August 13, 2014

SAP 042-611-031

ADDENDUM #1

ESTIMATED QUANTITIES

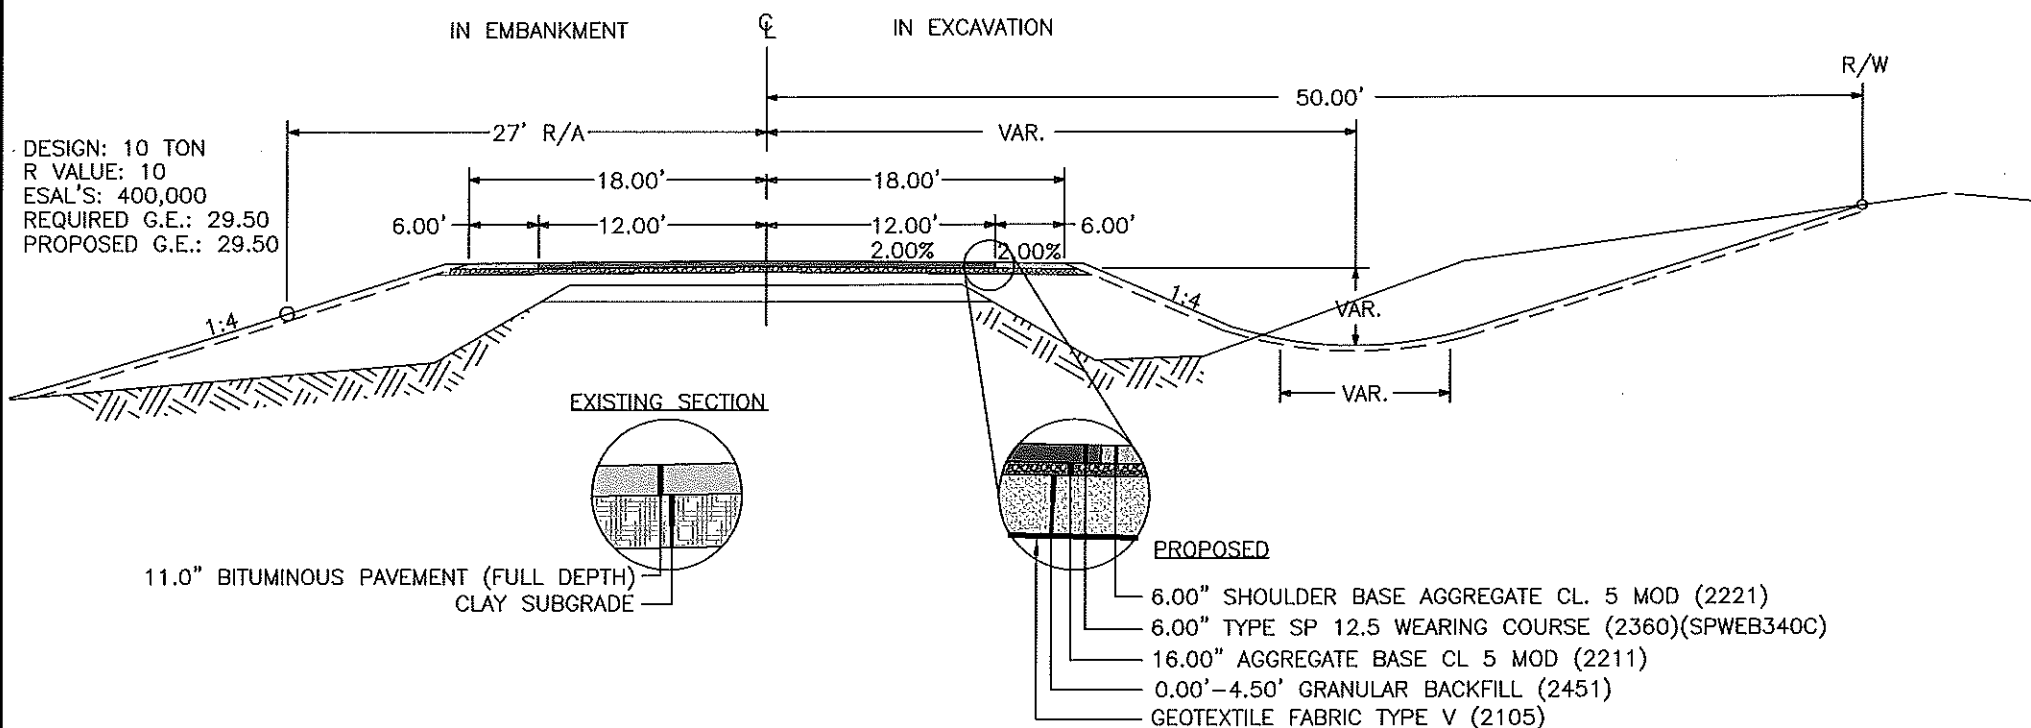
- Please find attached the amended plan sheet 2 of 7 (Item 2563.601 Removed).
- Please find attached an amended Schedule of Prices (Item 2563.601 Removed).
- Please eliminate sheet 6 of 7 (Detour Signing) from the plan set.
- Please eliminate Special Provision S-39 (2563) Detour Signing from the proposal.

Detour Signing has been installed by Lyon County forces
